## Planning Commission Staff Report

**SUBJECT:** PUD-85-08-13D and P12-0763

**APPLICANT:** Ware Malcomb for Mercedes Benz of Pleasanton

**PURPOSE:** Application for PUD Design Review and Conditional Use Permit approval for the demolition of the three existing buildings and construction and operation of an approximately 112,345 square foot automobile showroom and service facility for Mercedes-Benz of Pleasanton.

**FIGURE 3:** Proposed Site Plan

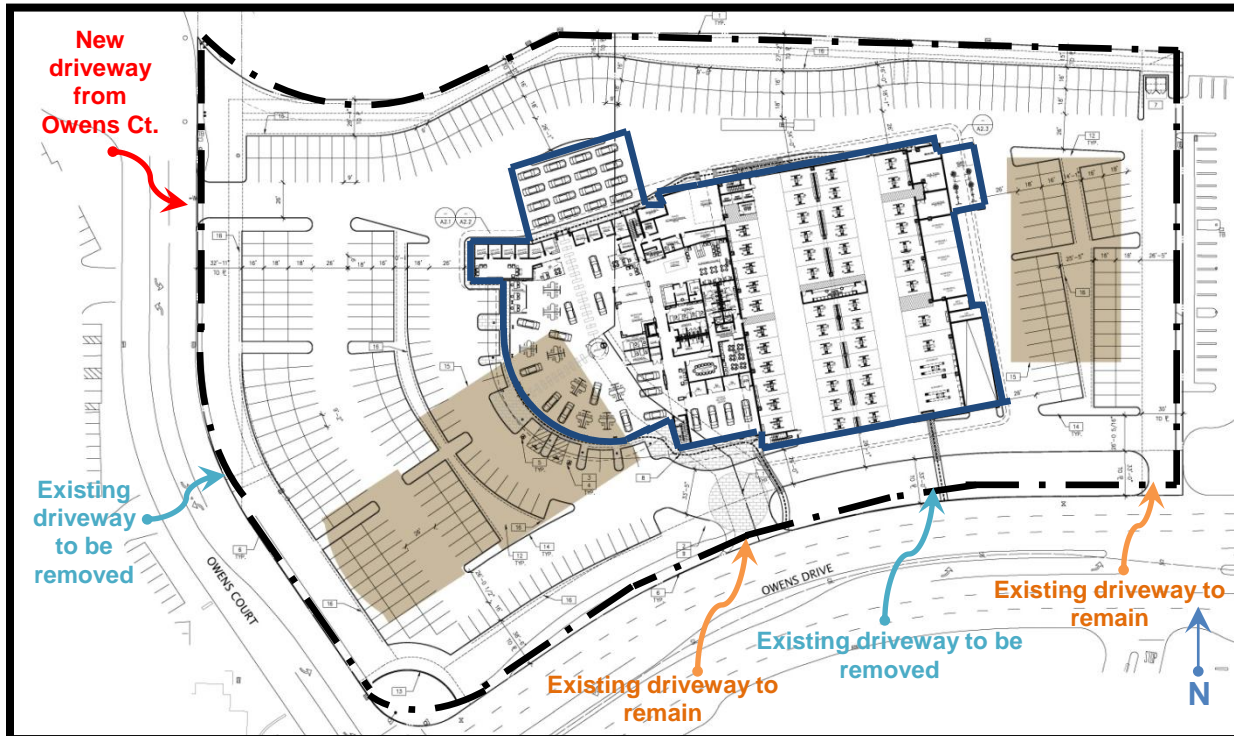
The site plan for the proposed project is provided on Sheet A1.1 of the project plans and shows the showroom and service facility. The location, orientation, and position of the

building are such that customers seeking servicing on their vehicle may pull into service lanes from the new driveway proposed on Owens Court. Other customers who are looking to purchase a vehicle may access the site from the driveway on Owens Drive and park in one of the parking stalls adjacent to the showroom entrance or opposite those adjacent to the showroom entrance. These parking spaces will be apparent to customers as “customer parking” since they will be empty and will not have any inventory vehicles parked in these spaces. Service related activities, including the car wash and detail bays are located on the eastern side of the building. The location of the building in the center of the three sites also allows for the off-loading of inventory vehicles on the subject property (instead of on either Owens Court or Owens Drive). The proposed landscaping plan (discussed in further detail in a subsequent section of this report) will enhance the site with a variety of trees, shrubs, and groundcover. Therefore, staff finds the site plan is appropriate overall.

**FIGURE 7:** Aerial view and photograph showing location of existing, proposed, and to-be-removed driveways

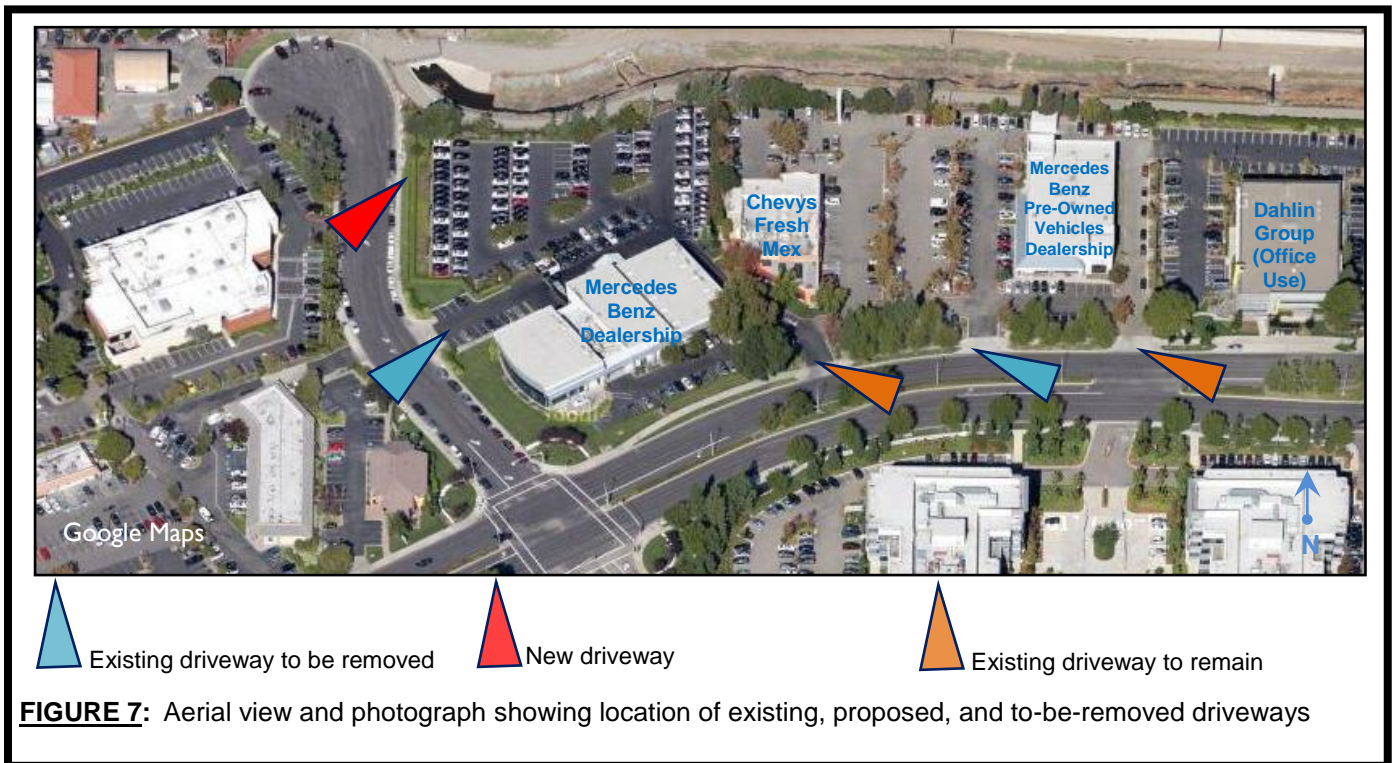
As noted previously in this staff report, the circulation on the site is expected to be adequate and the unloading of vehicle inventory is expected to be improved since there is adequate space on the subject site. The new driveway proposed on Owens Court near the end of the cul-de-sac and is thus not expected to create conflicts with through-traffic. Figure 9 consists an aerial photograph showing the area of Owens Court where the additional driveway is proposed and the locations of existing driveways to remain (two on Owens Drive) and existing driveways to be removed (one on Owens Drive and one on Owens Court). These locations are also shown on the site plan (Sheet A.1.1 of the project plans or Figure 3 of this report).
